Procurement #: 54502

RFP Title: :Bundled School Construction Classical High School Commercial Chiller and Reservoir & Leviton Elementary Schools RTU Replacements

Addendum #: 1

RFI Questions and Response

EXISTING FIRST FLOOR PLAN - LEVITON DUAL LANGUAGE SCHOOL

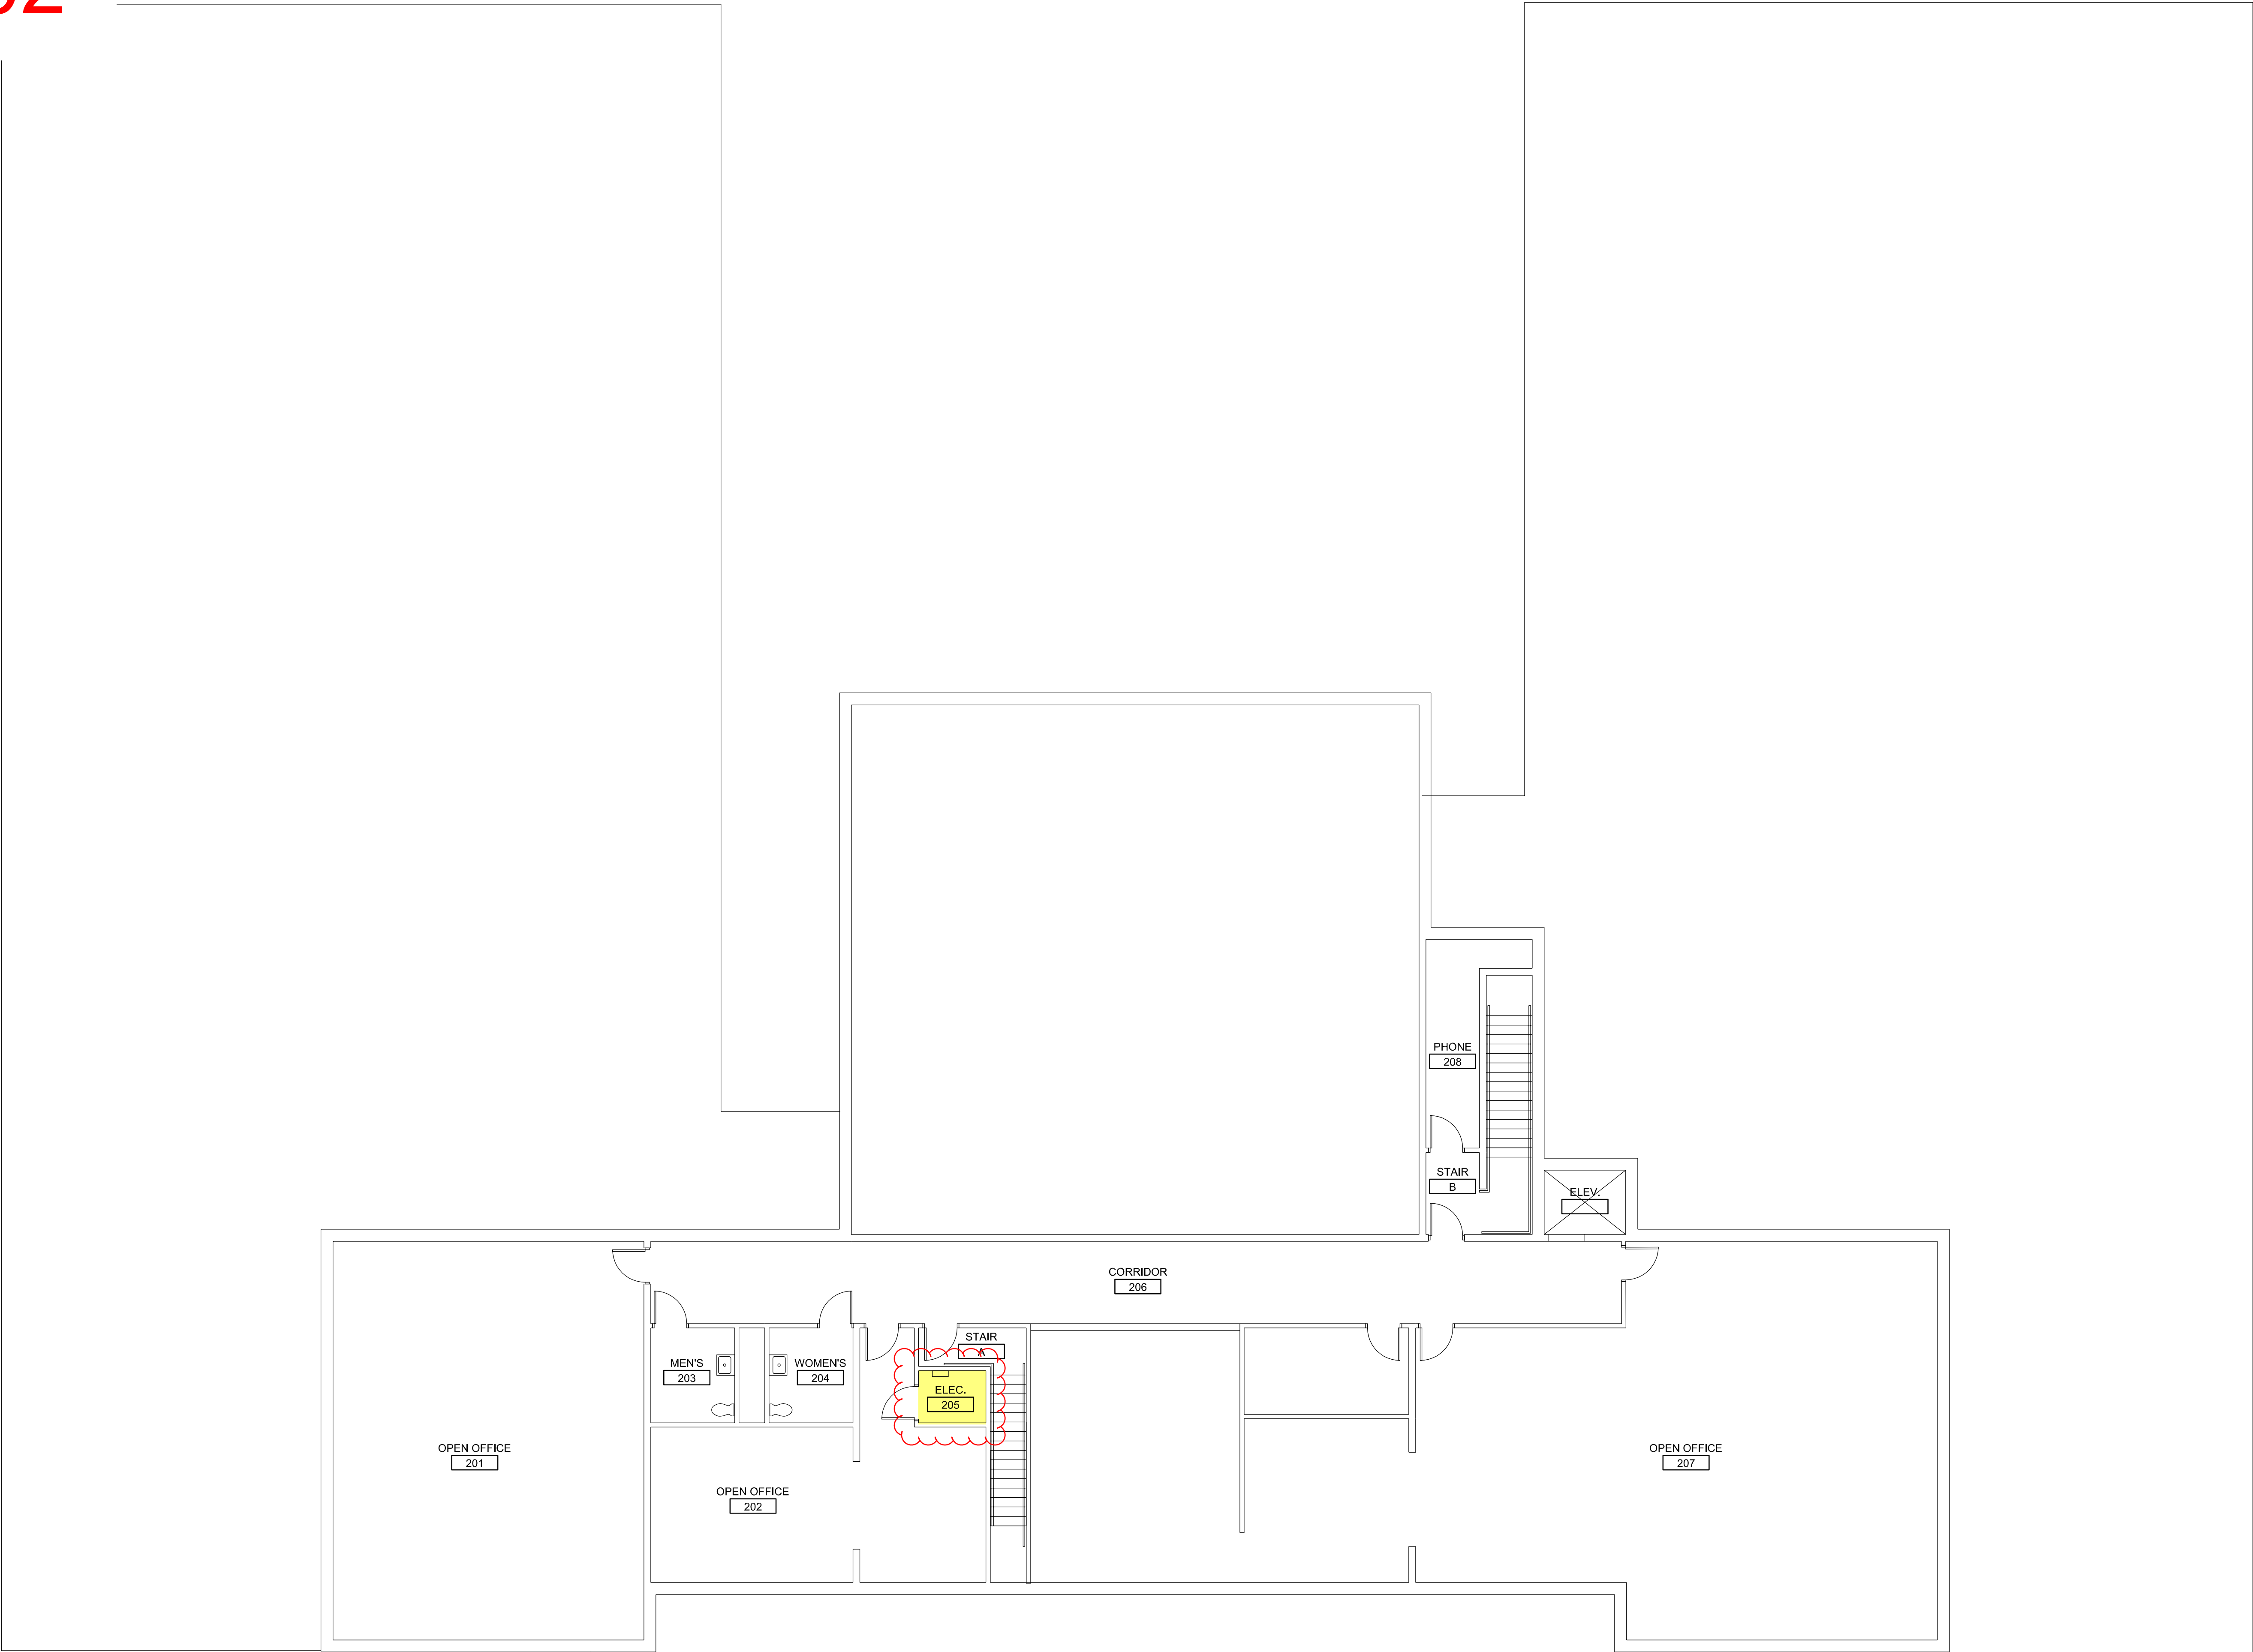
RFI-003		Leviton Dual Language	ME2.2	Unclear as to whether we are using existing circuit for newly furnished WP GFCI	Is there an existing circuit for the new WP GFCI or will EC need to provide one? Can you provide drawings of the building that indicate where main electric room is located?	Provide and install new receptacle near RTU-10. Used existing 20A-1P circuit breaker in main electric room. Run 20A (2#12 & 1#12G in 3/4"C) feed from circuit breaker to receptacle.
RFI-004		Project Wide	Project Wide	Chiller specs are not included	Can you provide specifications for each chiller unit so as to confirm if there are additonal circuits needed for internal components such as buffer tanks, evaporator heaters, heat tracing, etc.	New chiller is single point power, no additional electrical connections required for buffer tanks, heat trace, etc.
